# 1968 Corvette: Service News: Corvette Folding Top Compartment Lid to Folding Top Interference (SN-68-20)

**Subject:** Corvette Folding Top Compartment Lid to Folding Top Interference (SN-68-20)

**Model and Year:** 1968 Corvette

**Date:** April 1968, Volume 40, Issue Number 4

**Fig. 12—Remove 1/8" From Lid Stops**

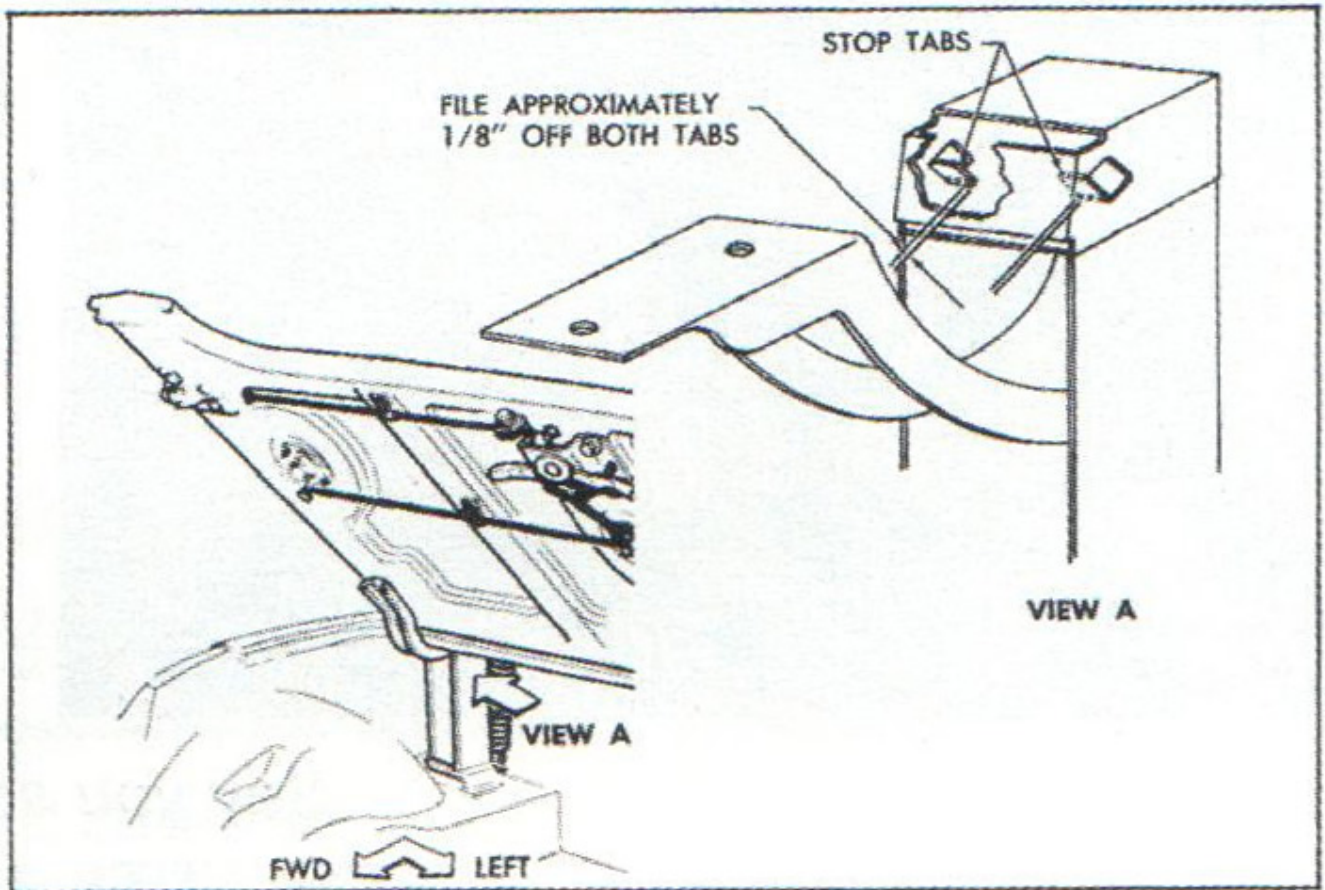
It has been found that the rear compartment lid on some 1968 Corvettes interferes with the convertible top when the top is being raised or lowered. This interference is easily eliminated by filing approximately 1/8" off the existing hinge stops (right and left side). Removing 1/8" from the hinge stops, as shown in Figure 12, allows the rear compartment lid to raise farther thus eliminating the interference condition. The stops referred to are simply tabs that has been punched out of the hinge support members.
